**From:** Anna Kramarczyk <Anna.Kramarczyk@midsussex.gov.uk>  
**Sent:** 07 January 2026 16:23:43 UTC+00:00  
**To:** "Steven King" <Steven.King@midsussex.gov.uk>  
**Subject:** Re: DM/25/3203 Proposal Discharge of planning condition 13 Part A, C, E and F and planning condition 23 relating to DM/23/0810

Re: DM/25/3203 Proposal Discharge of planning condition 13 Part A, C, E and F and planning condition 23 relating to DM/23/0810  
Based on the recently submitted information please see my comments in [Blue](#);

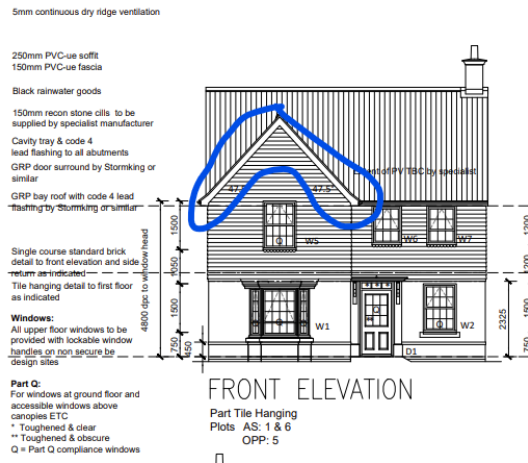
- Regarding facing materials and their applications there seem to be some discrepancies between the drawings. However, provided set of the elevations show the facing materials being applied as per Material Plan which is welcomed.

Nearly all elevations are acceptable subject to minor changes/correction listed below:.

- The FAIFBURN house (plots 1, 6 and opp. 5). I have doubts about the use of uPVC fascia and soffit at the those gable fronts (these units are located at the site entrance and are closing the vista) and would like this one detail to be revisited and improved.
